**Falmouth Planning Board**  
**Select Board Meeting Room, Town Hall – January 13, 2026**  
**Meeting - 6:30 pm**  
**MINUTES**

**RE: Site Plan Review & Special Permit applications**  
**Applicant: Fashion Foods, LLC**  
**Lot 1B, 0 Worcester Court, Falmouth**  
**Assessors ID: 39 15 048 001B**

## Combined Review – Planning Board – Site Plan Review, Special Permit Zoning Board of Appeals – Special Permit Application 071-25

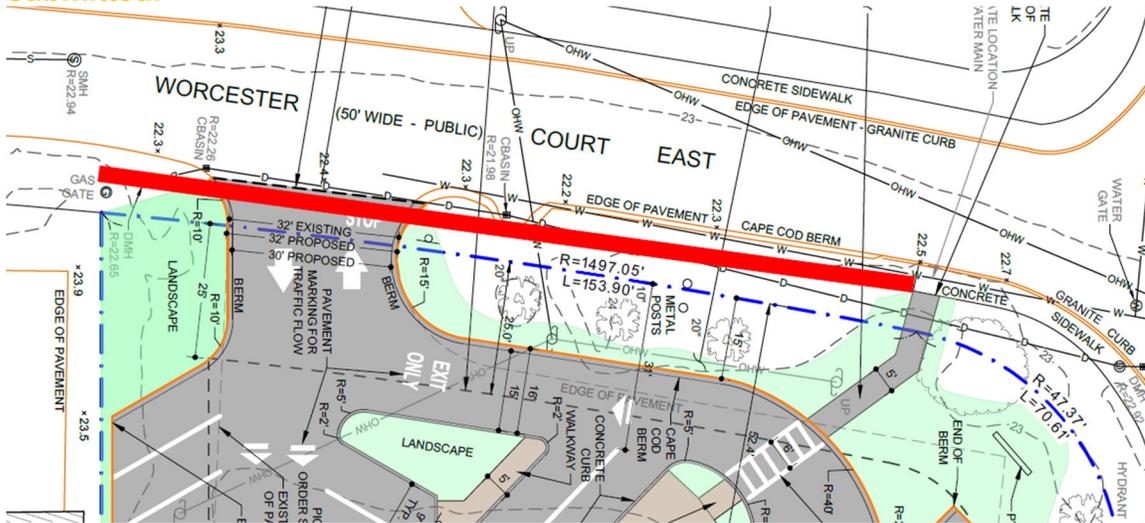
*7. Both entrances exceed the maximum opening width in §240-14.11(4)b. The turning movement shown for the WB62 vehicle does show that additional width is required for this vehicle to access the site.*

*The Boards should determine if the Applicant has demonstrated that the greater width is needed.*

The Applicant's Engineer indicates that the proposed driveway widths are required. We would not have an issue approving the additional width under a street permit.

The Boards should decide if the plans should be revised to meet the Zoning requirements, or if the Applicant's Engineer has demonstrated the need for relief as allowed by §240-14.11(4)b.

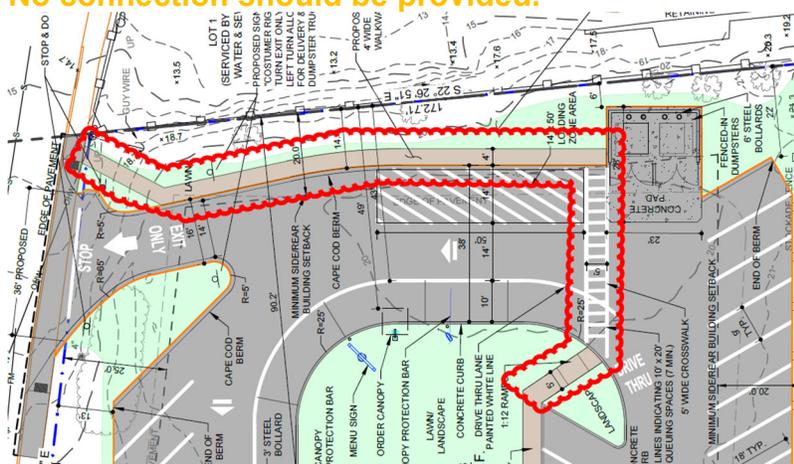
The plans were revised to include a sidewalk connection to the existing sidewalk in Spring Bars Road, however, the Applicant's Engineer offers reasons for not including this in the final design due to safety concerns. If a connection along Spring Bars Road is not included in the final design, pedestrians walking west on Spring Bars Road can access the site by walking up to Worcester Court to the sidewalk connection to the front door.

The Boards should decide if:

- The pedestrian connection to Spring Bars Road should remain as currently shown (see revision cloud area below);
- Alternate routes should be explored; or
- No connection should be provided.
